Work Order ID 91104

Item ID: 646.9800 Accept *N900040100* Setup Start *NS1*
 Revision ID: Stop *NS2*
 Item Name: Deflector Extrusion
 Start Date: 10/01/12 Start Qty: 360.00 *360* Cust Item ID:
 Required Date: 11/06/12 Req'd Qty: 360.00 *360* Customer:
 Reference:

Parent Item Name: Deflector Extrusion

ORIGINAL DATE (MM-DD-YY) 04-21-09 DRAWN BY: J. JACKSON CHECKED BY: P. BRAVO DRAWING APPROVAL P. BRAVO 04-21-09 CONTRACT NO.		APICAL INDUSTRIES 2608 TEMPLE HEIGHTS DR. OCEANSIDE, CA, 92056-3512 (760)724-5300	
UNLESS OTHERWISE SPECIFIED DIMENSIONS ARE IN INCHES TOLERANCES ARE: 1. FRACTIONS 1/16" 2. DECIMALS .001 3. ANGLES .1°		DEFLECTOR	
SET: 07M26	DWG. NO: 646.9800	REV. N/C	SCALE: NONE
SHEET 2 OF 6		SHEET 2 OF 6

DRAWN BY: J. JACKSON CHECKED BY: P. SPALVO DESIGNED BY: J. JACKSON P. SPALVO		APICAL INDUSTRIES 2608 TEMPLE HEIGHTS DR. OCEANSIDE, CA. 92056-3512 (760)724-5300	
CONTRACT NO.		DEFLECTOR	
SIZE: B DATE: 07/12/16 SCALE: NONE	DWG NO: 646.9800	REV: N/C	SHEET: 3 OF 6

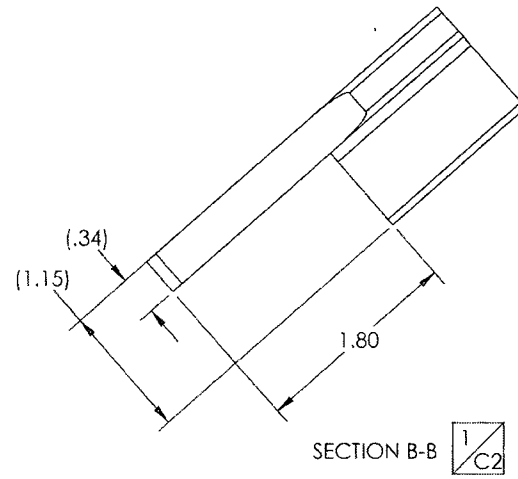
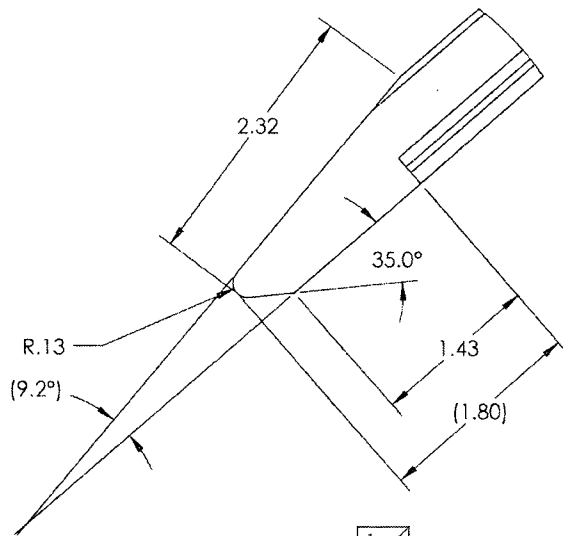
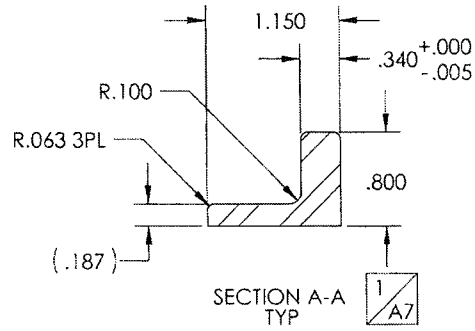
The specifications included on the subject cannot be produced by our mill. WE could produce the angle on page 3 of 6 of the NC deflector package and we could produce the channel, however we would have to offer both as 7075-T6511 AMSQQ-A-200/11. Please let me know if you can use the specification offered and I will have our engineering department prepare a quote.

Isam,
The material recommended by Universal Alloy is an acceptable alternative.
